INNER WEST COUNCIL

DEVELOPMENT ASSESSMENT REPORT

Application No.	DA201500499.02
Address	326-330 Marrickville Road, MARRICKVILLE NSW 2204
Proposal	Application under Section 4.55 of the Environmental Planning and Assessment Act to modify Modified Determination No. 201500499.01 dated 31 May 2017 to carry out changes so as to divide a 2 bedroom unit into 2 x 1 bedroom units and increasing their extent, increasing the total number of units to 40 and to carry out other changes to the stairwell along the eastern boundary.
Date of Lodgement	5 October 2018
Applicant	Benson McCormack Architects
Owner	Marrickville Apartments
Number of Submissions	Nil
Reason for determination at Planning Panel	Clause 4.6 variation exceeds officer delegation
Main Issues	<ul style="list-style-type: none"> • Visual and acoustic privacy • Use of communal open space
Recommendation	Approval
Attachment A	Recommended modified conditions of consent
Attachment B	Plans of proposed development

Figure 1: The landscaped area of communal open space is seen in the centre of frame with proposed Units 105 & 108 shaded pink and to the left.

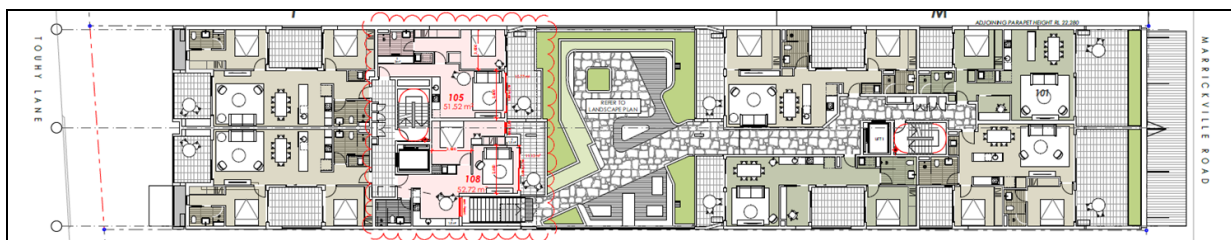
The modified approval for DA No. 201500499.01 provides a total area of communal open space of approximately 192.22m², or 15.21%, located primarily on Level 1, between the two towers. The proposed modification will slightly reduce the total area of communal open space in a small section of the southern pathway and a small section of landscaped area. This is a result of accommodating the private open space for proposed unit 108 and a shift north of the eastern stairwell.

The amount of landscaped area lost is approximately 6.39m². The slightly reduced landscaped area will continue to have adequate dimensions and shape to provide landscape character and opportunities for group and individual recreation and social interaction (refer to **Figure 1**). It is considered that the landscaped communal open space area will continue to achieve the objective of the ADG to provide an adequate area of communal open space to enhance residential amenity and to provide opportunities for landscaping.

It is considered that the useability of the communal open space will not be diminished with the proposed removal of a small section of pathway, as the eastern stairs will continue to be accessible to and from the approved pathway.

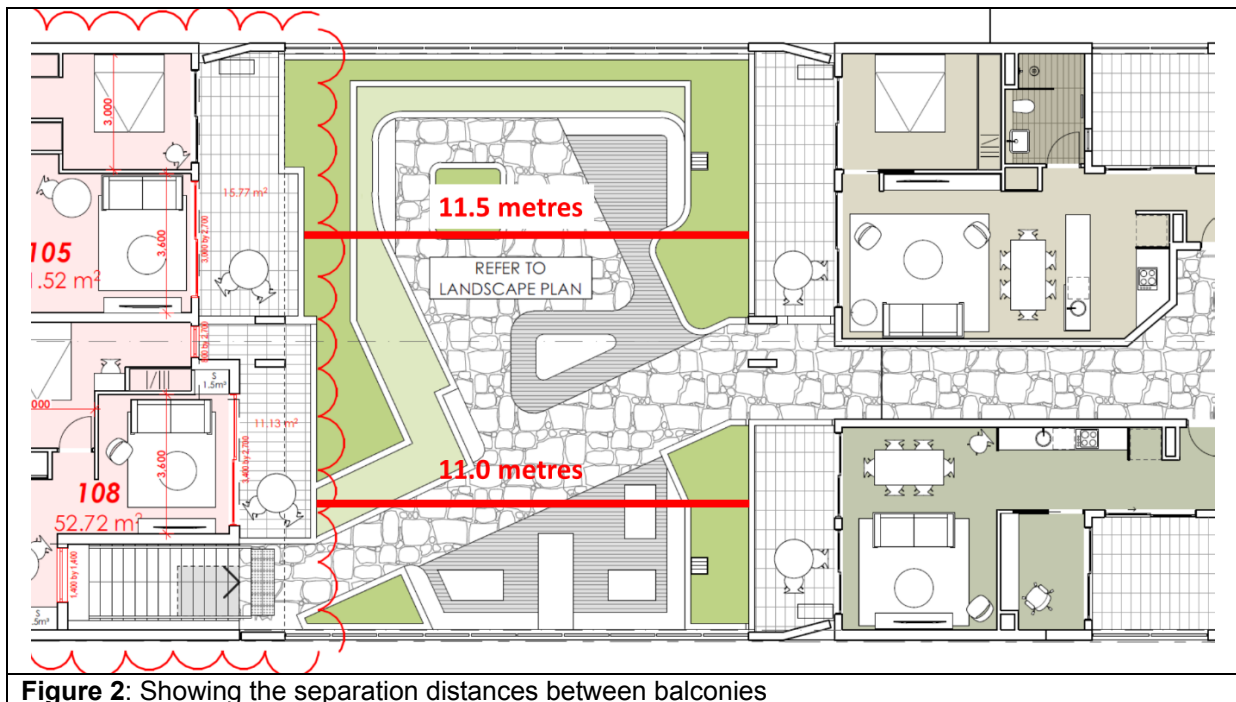
The proposed modifications will result in the edge of the balconies of both Units 105 and 108 moving further north than as previously approved and encroaching slightly over the landscaped communal open space (COS) area. This will result in both balconies being less than the desired 12 metres from the edge of balconies on the opposite side of the COS. The balcony of Unit 105 will have a separation distance of 11.5m and Unit 108 will have a separation distance of 11.0m (refer to **Figure 2**).

This minor variation from the ADG guideline is considered satisfactory in this instance because it has previously been determined in the consideration of the original DA that the proposal supports the desired future character of the area and provides acceptable residential amenity. In addition, the separation distance has been measured between the outside edge of two balconies. These balconies are located in front of living rooms and bedrooms and provide increased protection of the internal privacy of each apartment. To achieve this effect, an additional condition is recommended requiring solid or partially solid balustrades on each of the balconies affected.

Further, it is not considered desirable to require screening devices to be installed as these will negatively affect access to light and air. The approved landscaping of the COS area will aid in providing a privacy barrier (refer to **Figure 3**). As the proposed modifications will intrude into the approved COS area, a condition is included in the recommendation requiring the approved landscaping plan to be updated and to continue to include screening vegetation as per **Figure 3**.

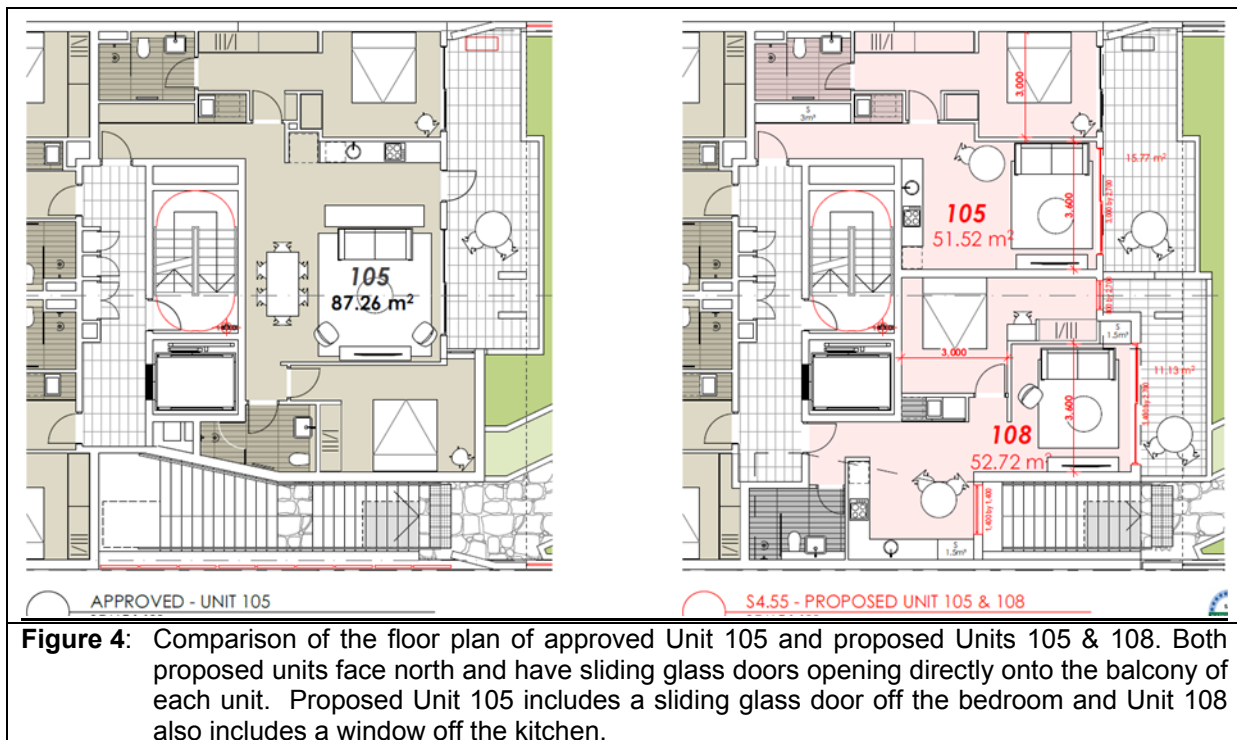
However, although 75% of units within the development will continue to be naturally cross-ventilated, the two proposed 1-bedroom units are not individually naturally cross ventilated as they are both single-aspect apartments. This does not represent a change from the approved Unit 105 which was also a single aspect apartment (refer to **Figure 4**).

While Unit 105 complies, the living room of Unit 108 has internal dimensions of 3.6m x 3.4m, resulting in a 200mm shortfall on a north/south axis. This room opens directly onto the balcony of the apartment thereby minimising any perception of this as a confined space. It is considered that the layout of both apartments includes dimensions that facilitate a variety of furniture arrangements and provide spaces for a range of activities and privacy between spaces within each apartment.

The balconies for each of the proposed units face north and are located adjacent to the living room to extend the living space. The area of each balcony exceeds the minimum required by the ADG (Unit 105 = 15.77m² and Unit 108 = 11.13m²) (refer to **Figure 4**).

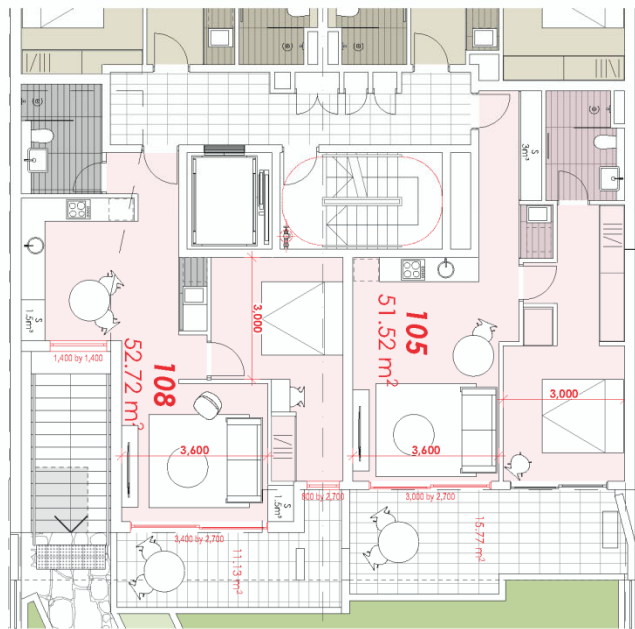
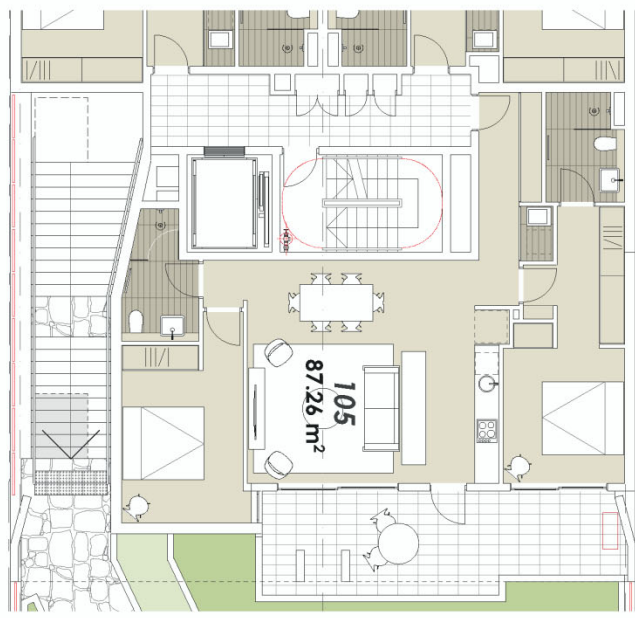
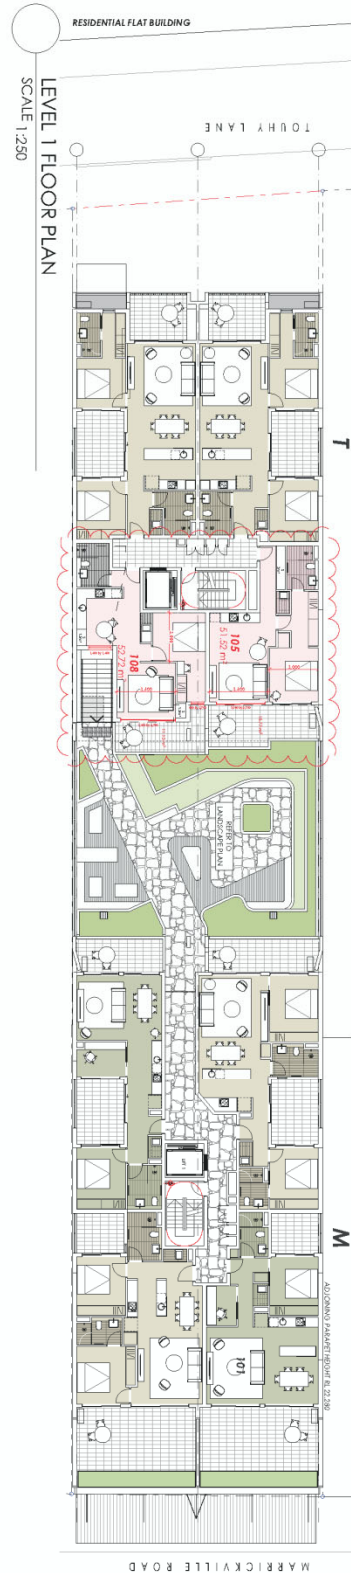
- 1D. The approved landscaping plans referred to in Condition 1 are to be updated and are to include suitable screening vegetation on the northern and southern sides, in front of the balconies located in front of the living rooms and bedrooms of Units 103, 104, 105 and 108. Details are to be provided to the satisfaction of the certifying authority prior to the issue of a construction certificate.
